**MONTGOMERY COLLEGE - OFFICE OF PROCUREMENT**  
**MACKLIN TOWER MBI FINANCE LAB SUITE 100, ROCKVILLE CAMPUS**  
**RFP NO.: 620-011**  
**RFP CLOSING DATE AND TIME: APRIL 30, 2020 @ 2:00 PM**

**ADDENDUM #4**  
**ISSUE DATE: April 27, 2020**

THIS ADDENDUM IS BEING ISSUED TO PROVIDE ANSWERS TO THE FOLLOWING QUESTIONS AND MAKE CHANGES TO THE RFP DOCUMENTS.

2  
A012  
EXISTING CURTAIN WALL DETAIL - STOREFRONT CONNECTION  
3" = 1'-0"

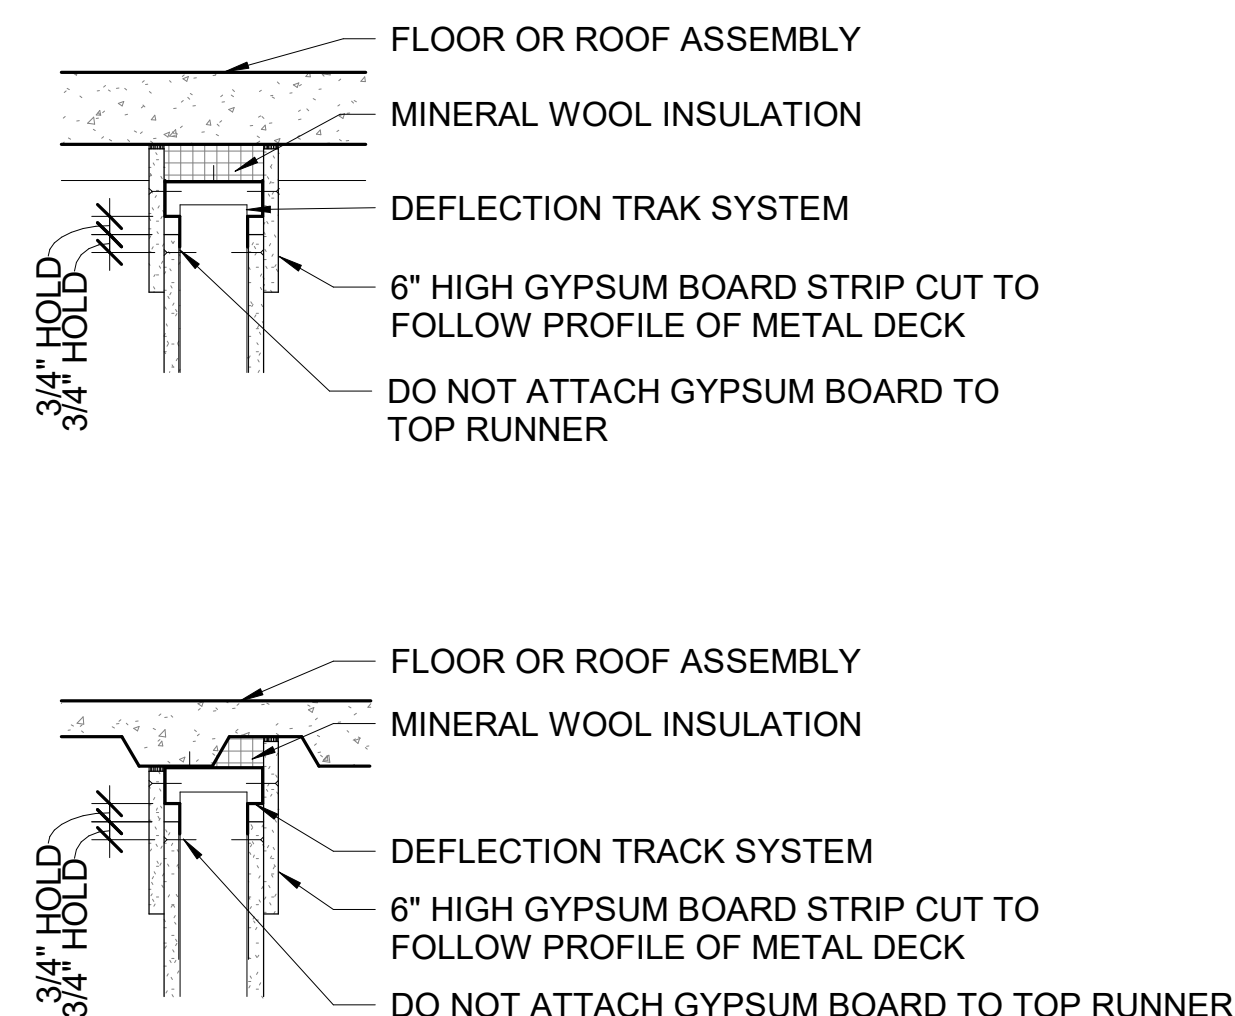
- Existing Curtain Wall Detail – Storefront Connection has been modified.
- Item 4-17 Drawing Architectural A4.01 – Enlarge Plans and Elevations
- Section 1 has been updated to show extent of ticker along storefront.

TRANSITION DETAIL - GWB SOFFIT  
3" = 1'-0" REFERRED FROM A112

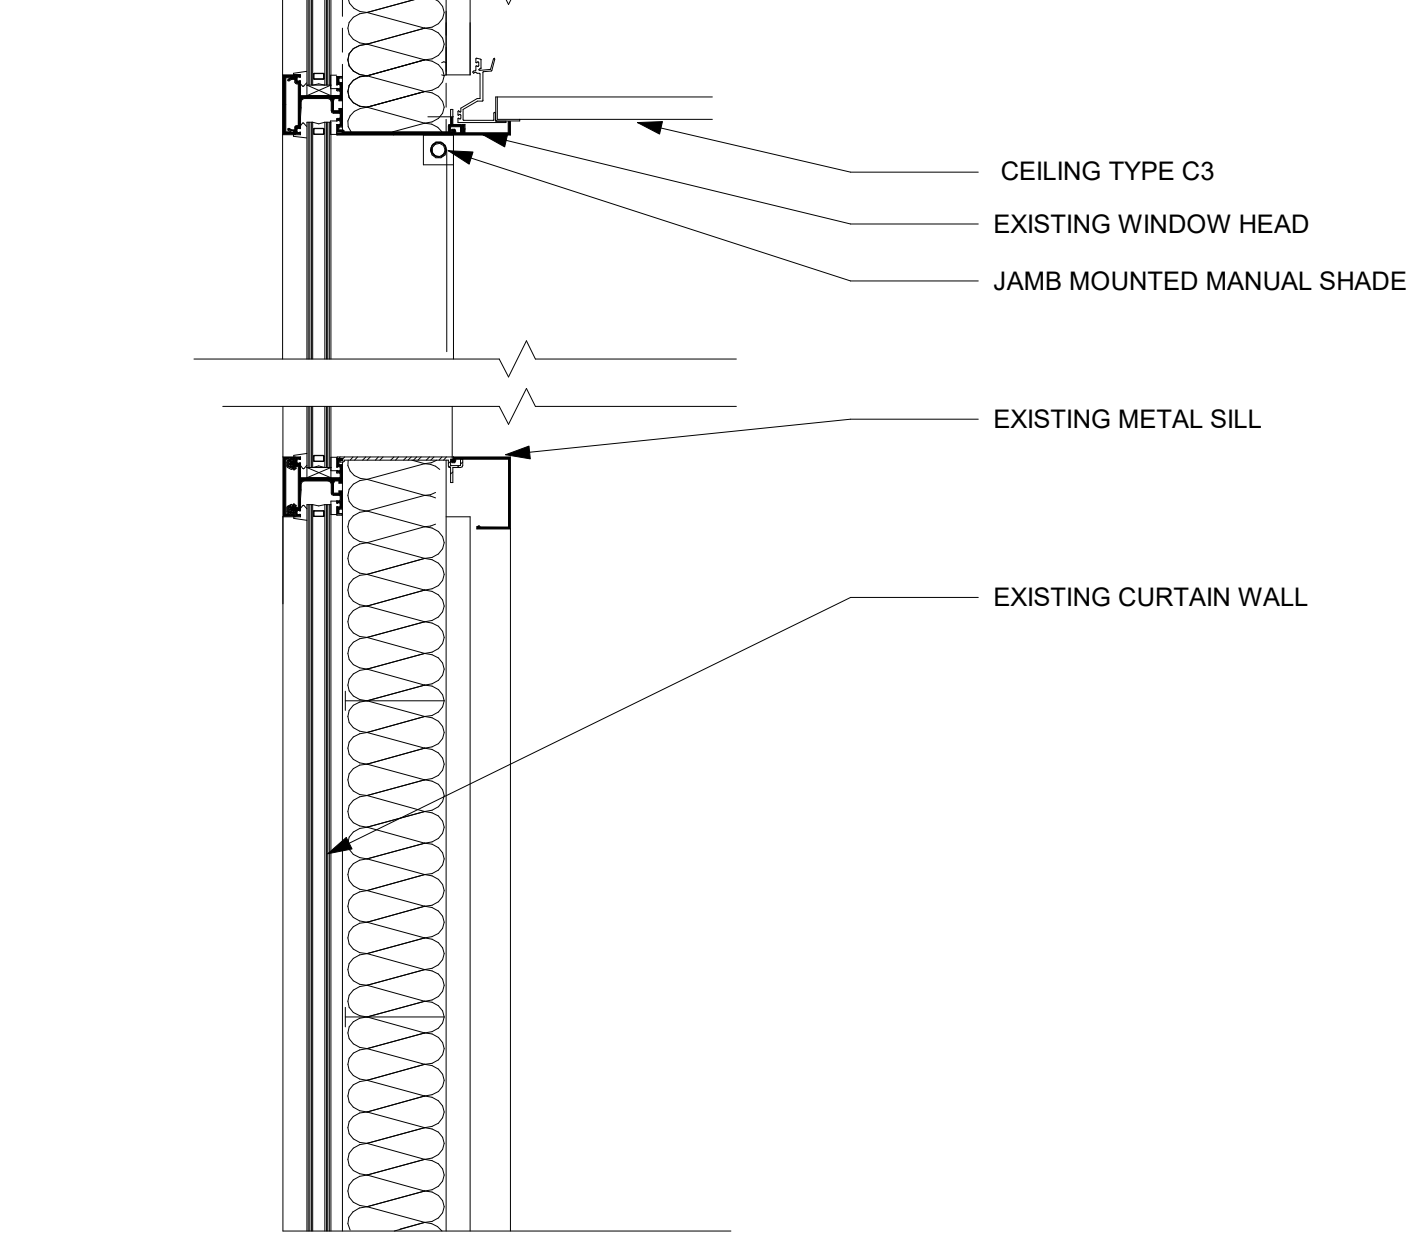
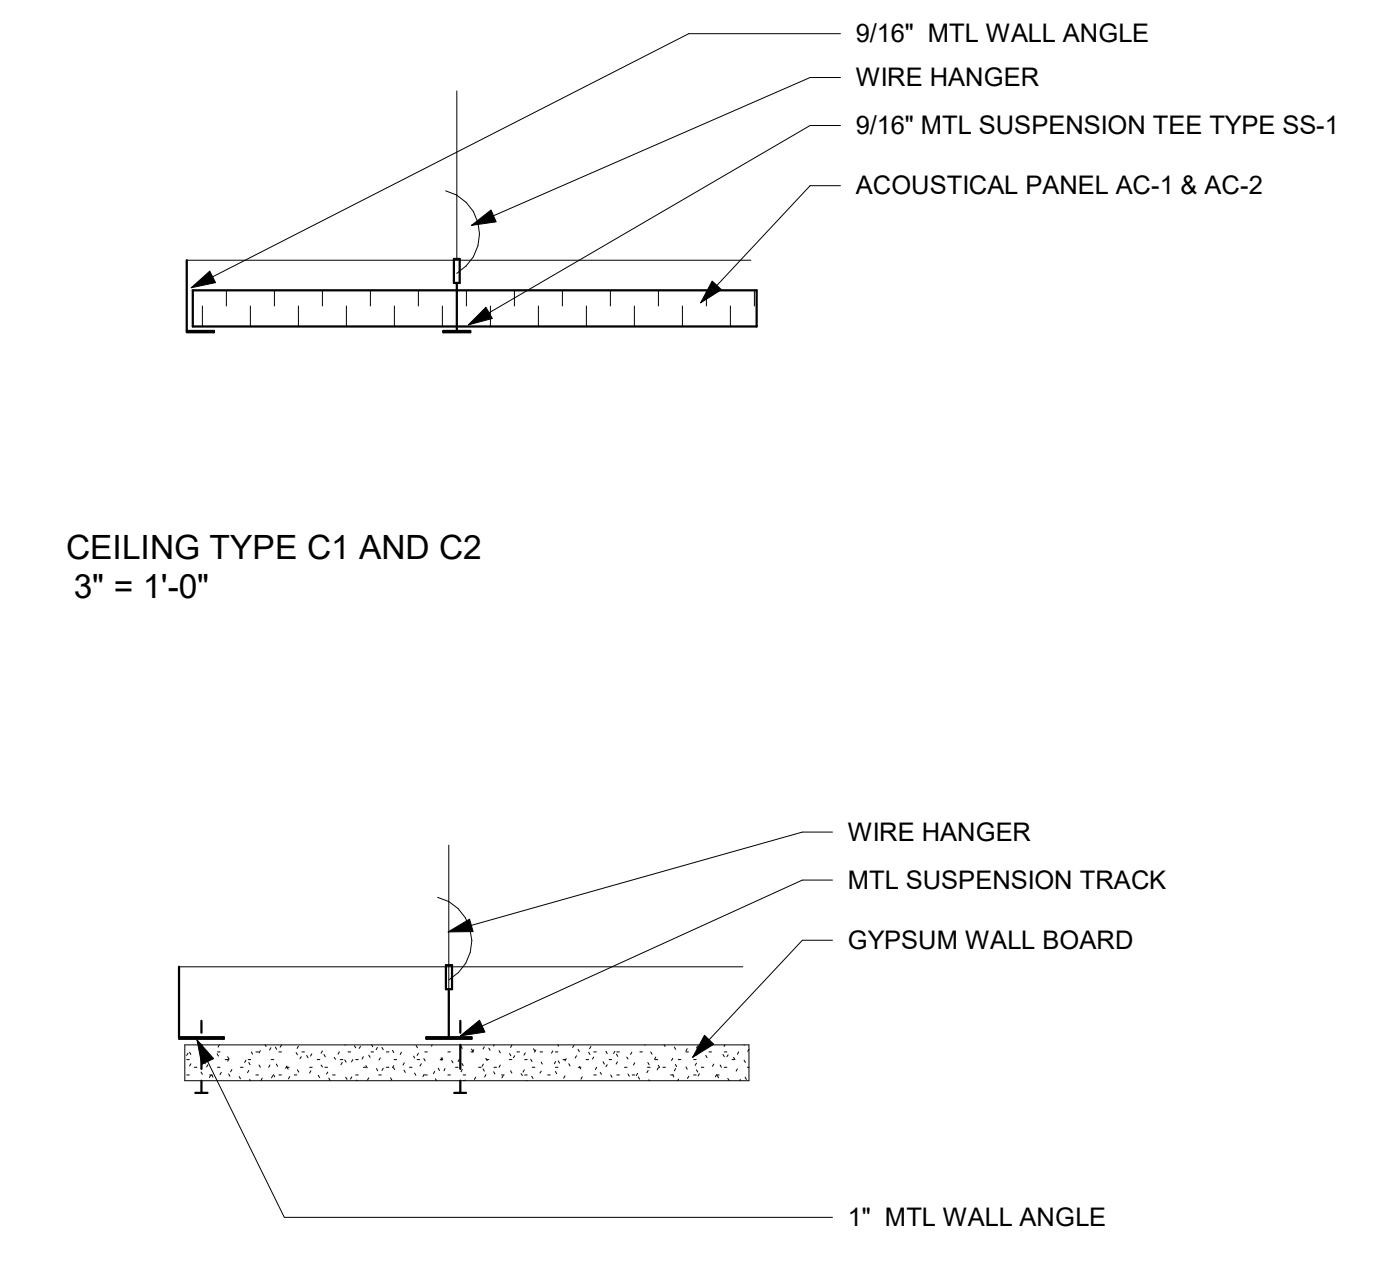
- Item 4-19 Drawing Architectural A6.07 – Finish Schedule and Details
  - Transition Detail – GWB Soffit has been modified.

DRAWING NO:  
**P2.01**  
 BKM# 19106.01

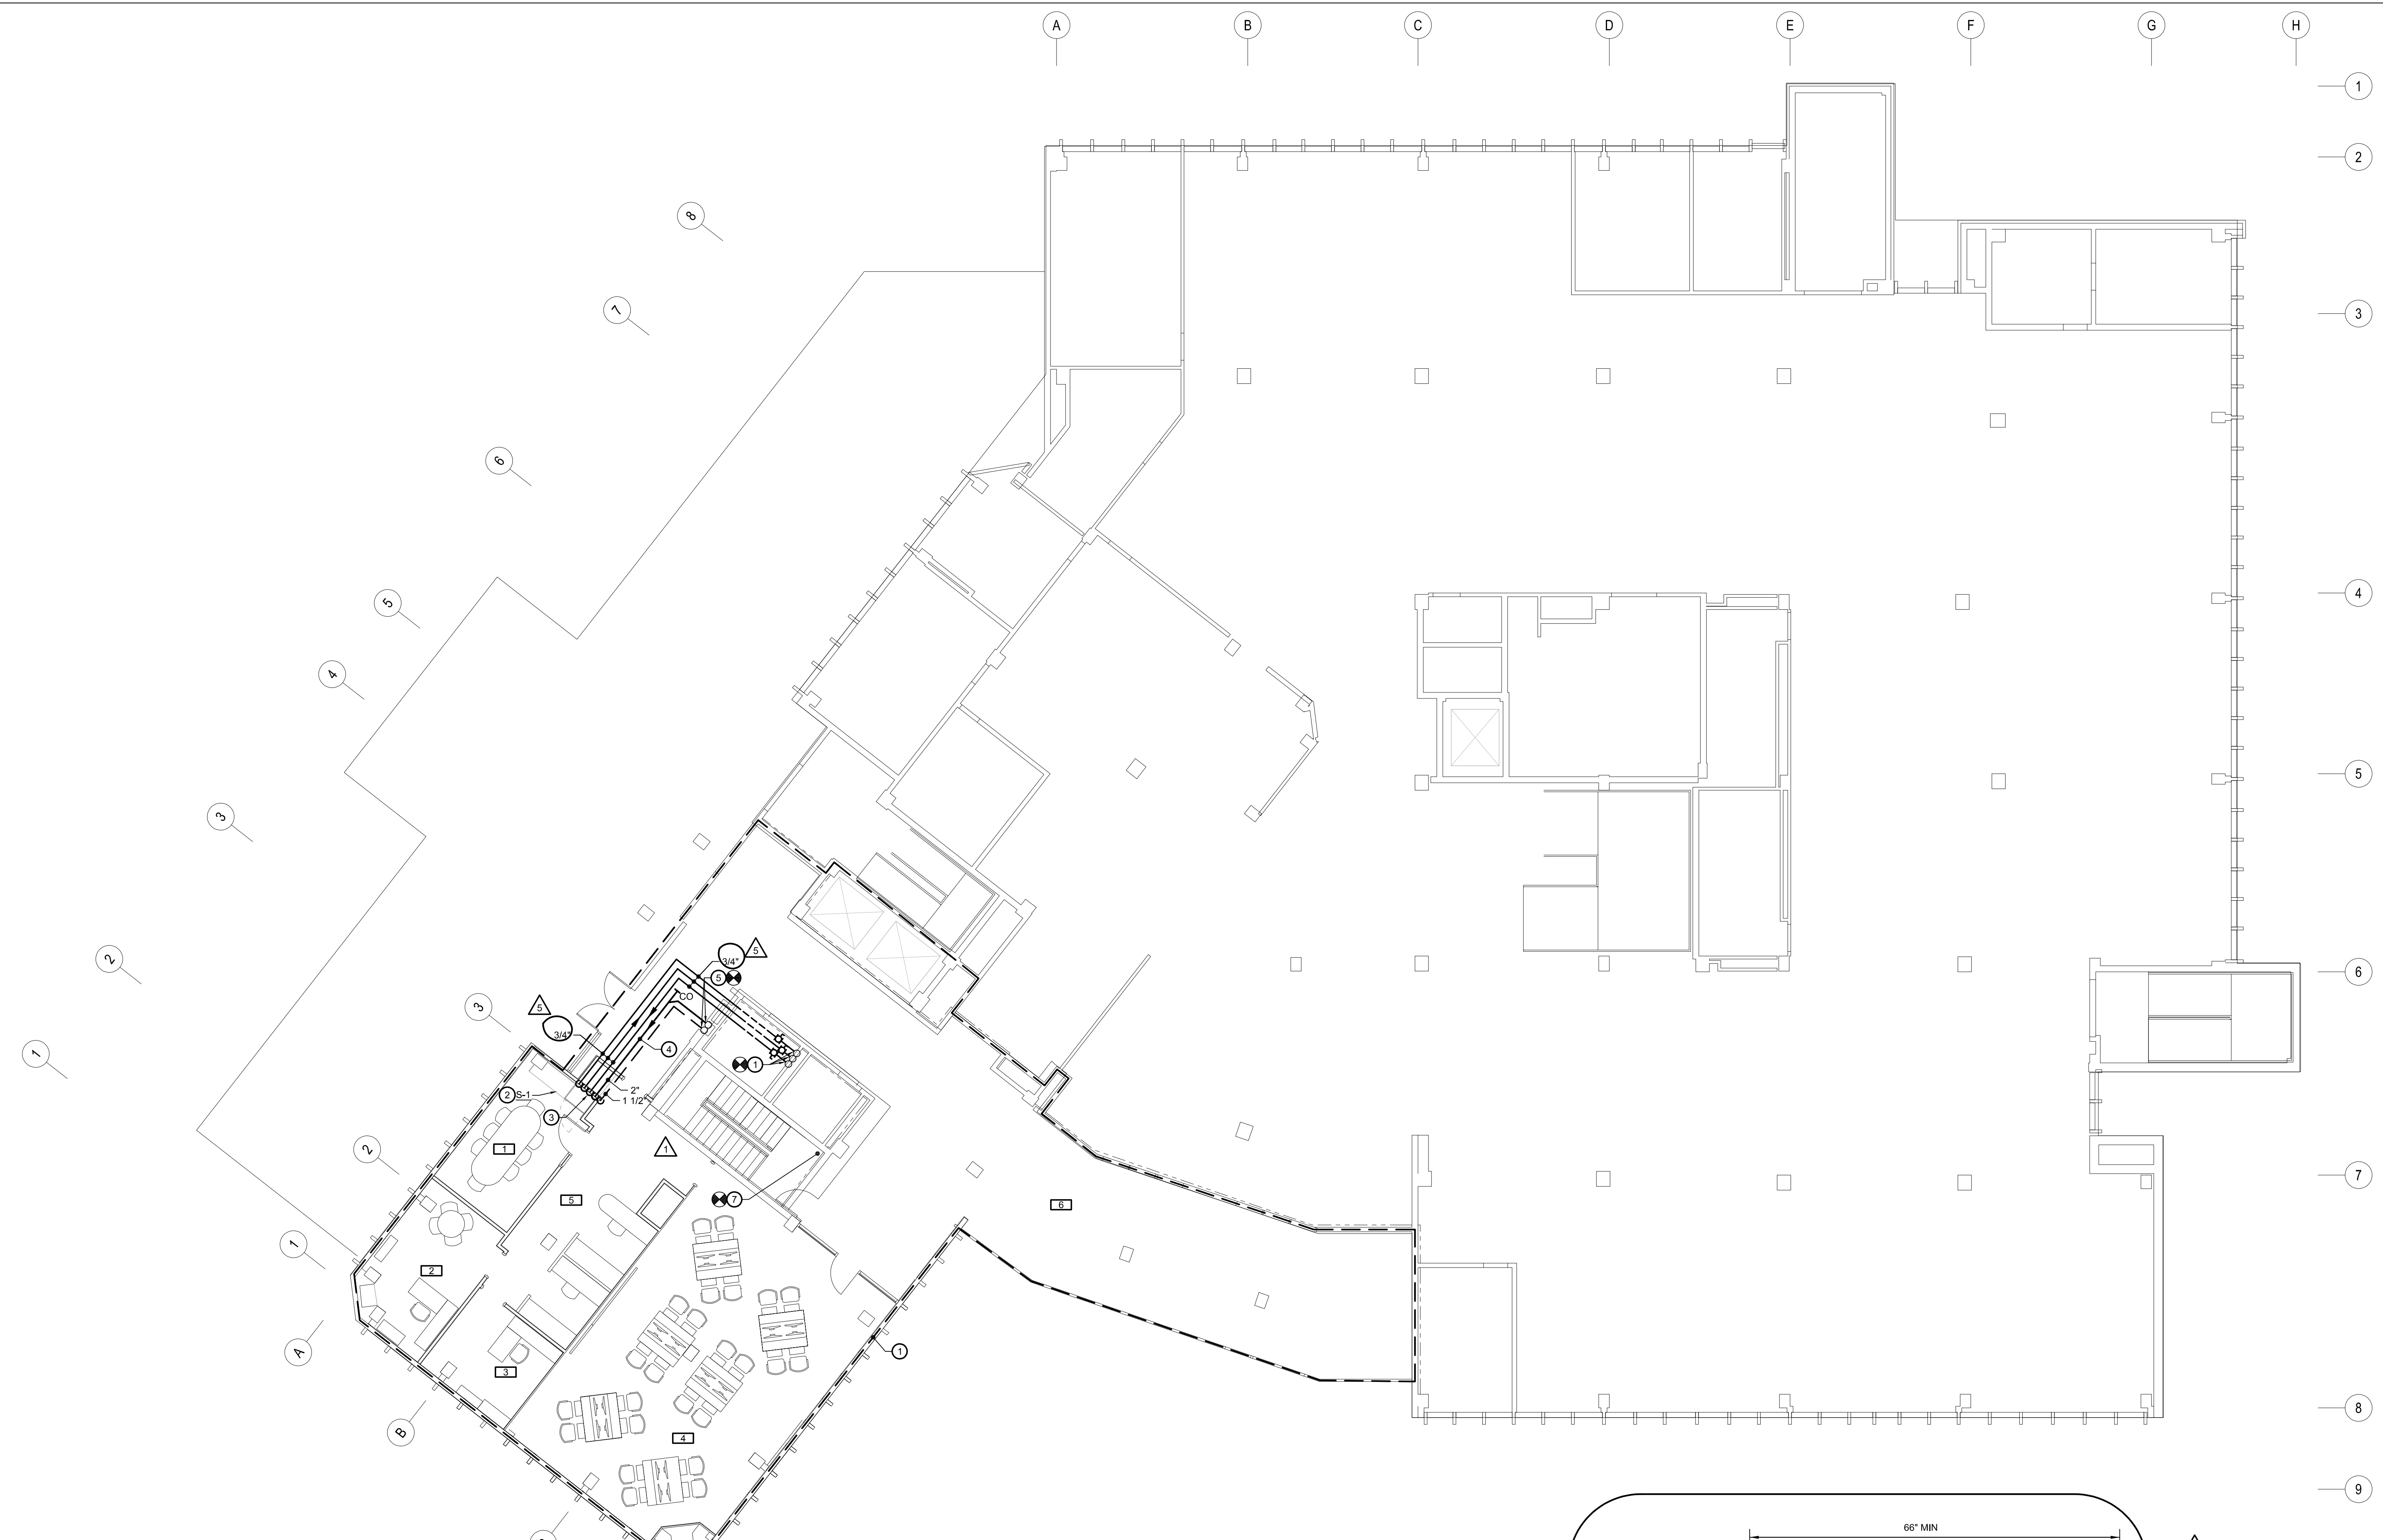
- Item 4-21 Drawing Plumbing, P2.01 – Mechanical Schedules
  - Lawler Model 570 point of use thermostatic mixing valve has been specified to serve S-1.
  - 1.5 GPM aerator has been specified for fixture S-1.
  - Minimum domestic water pipe size increased to ¾”.
